SERVICE BULLETIN

LG Electronics Inc.

Buyer Model: LDS5811,LDF7811,LDF7810,LDF6810,LDF8812

Subject: BLDC Motor Magnet Crack

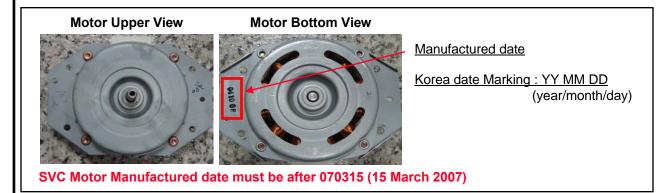
When replacing the BLDC motor (P/n 4681ED1004A) in the dishwasher, verify the motor manufacturing date as shown below. Improved BLDC motor began 15 March 2007. (Verify date on motor – the part number has not been changed)

If manufacturing date is before 15 March 2007 DO NOT USE THE MOTOR.

Manufactured date is marked on the bottom of upper bracket.

The date code is the only visible difference between parts. The part number is unchanged.

All old stock (dated prior to 15 Mar 2007) must be scrapped. All old motors will be replaced with new stock.
